April 22, 2024

RE: Opposition to the Vulcan Comal Quarry Plant
TCEQ Edwards Aquifer Permit #: 13001906

General Aquifer Flowpath

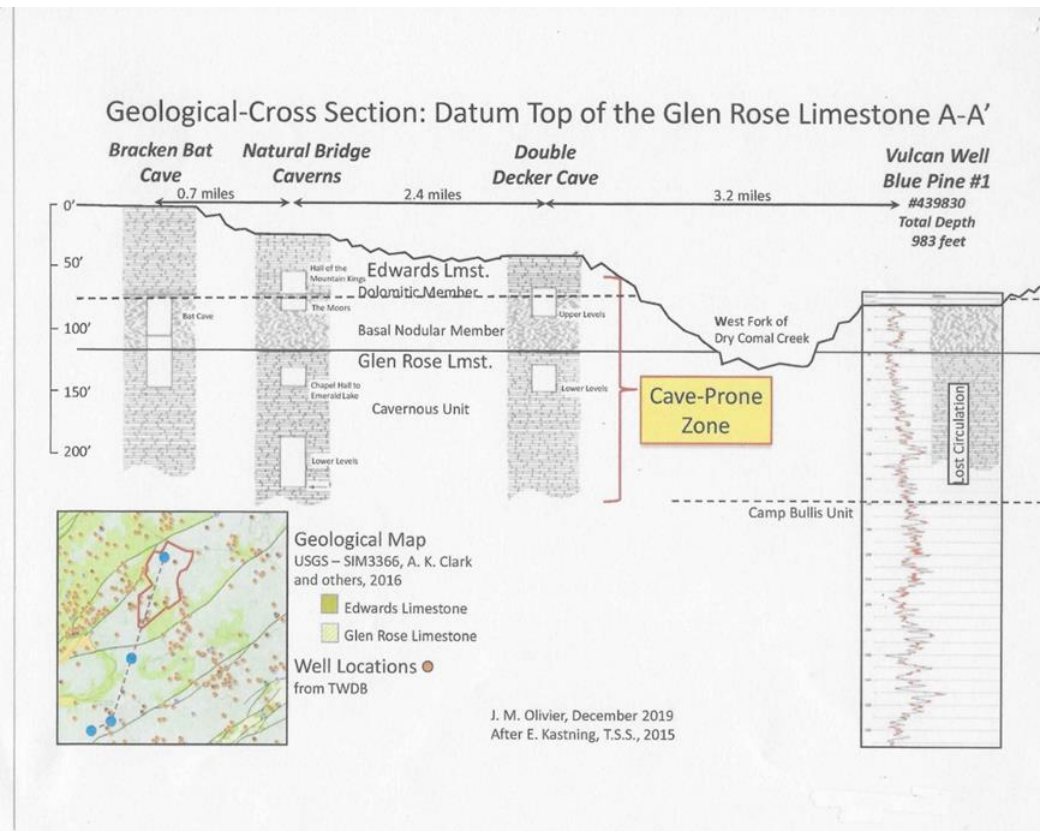
Of note: Groundwater flow from the Vulcan site generally would move southeast then shift to the east then northeast toward Hueco and Comal Springs. Map source Edwards Aquifer Authority.
